The Keadby Next Generation Power Station Project

Document Ref: 8.8

Applicant's Comments on Deadline 1 Submissions (submitted at Deadline 2)

Date: February 2026

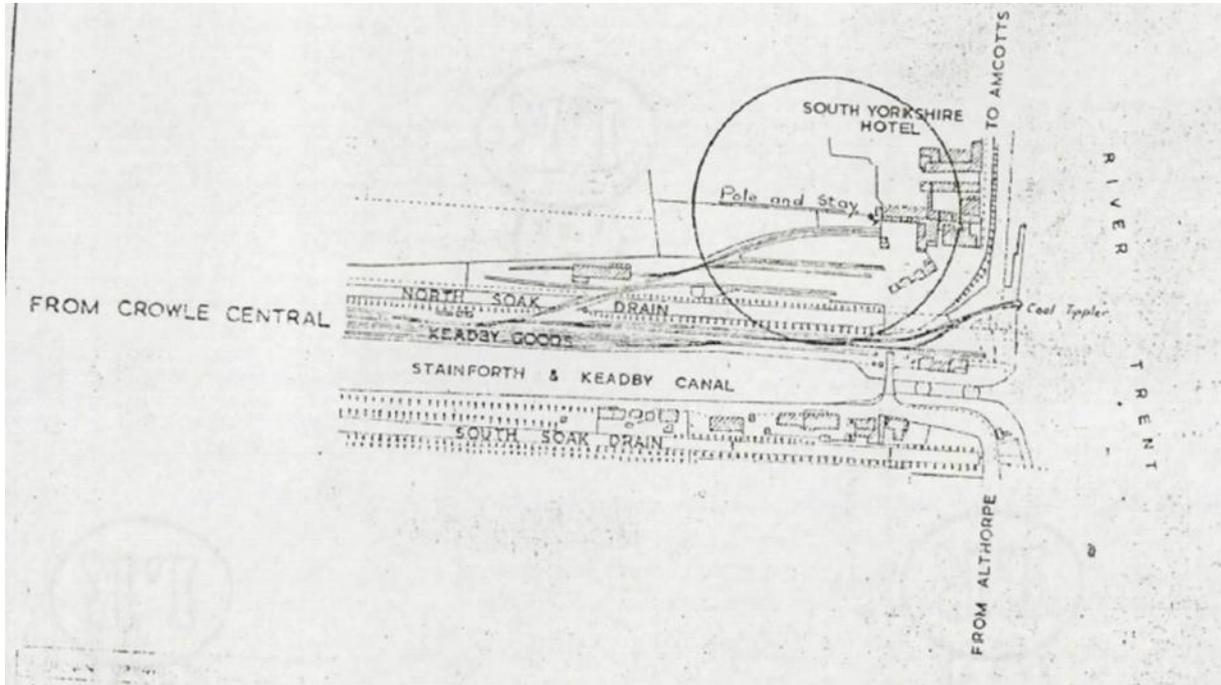
2	<p>Plots 3-168, 3-193 and 3-195</p> <p>NR's rights over the plots set out below are required for the purposes of carrying on NR's railway undertaking and so must not be extinguished or impeded (as applicable) by the Promoter through powers granted under the Order.</p> <p>NR submits that the proposed extinguishment of its rights over Plot 3-168 and the impediment of its rights over Plots 3-193 and 3-195 will cause a serious detriment to NR's statutory undertaking and so do not satisfy the test in section 138 of the Planning Act 2008</p>

- 12.1.6 The British Transport Commission (predecessor to Network Rail) previously owned land along the northern boundary of the Stainforth and Keadby Canal for the purposes of a railway running west from Railway Wharf to link in with the main line known as the Keadby Jetty Branch line. They therefore owned the land coloured blue in the historic map extract below:

- 12.1.13 In summary, the rights held by Network Rail in respect of Plots 3-168, 3-193 and 3-195 are obsolete, are not enforceable and are not used for the purpose of their undertaking. There is therefore no impact or impediment whatsoever on Network Rail's statutory undertaking such that section 138 of the Planning Act 2008 is more than satisfied.
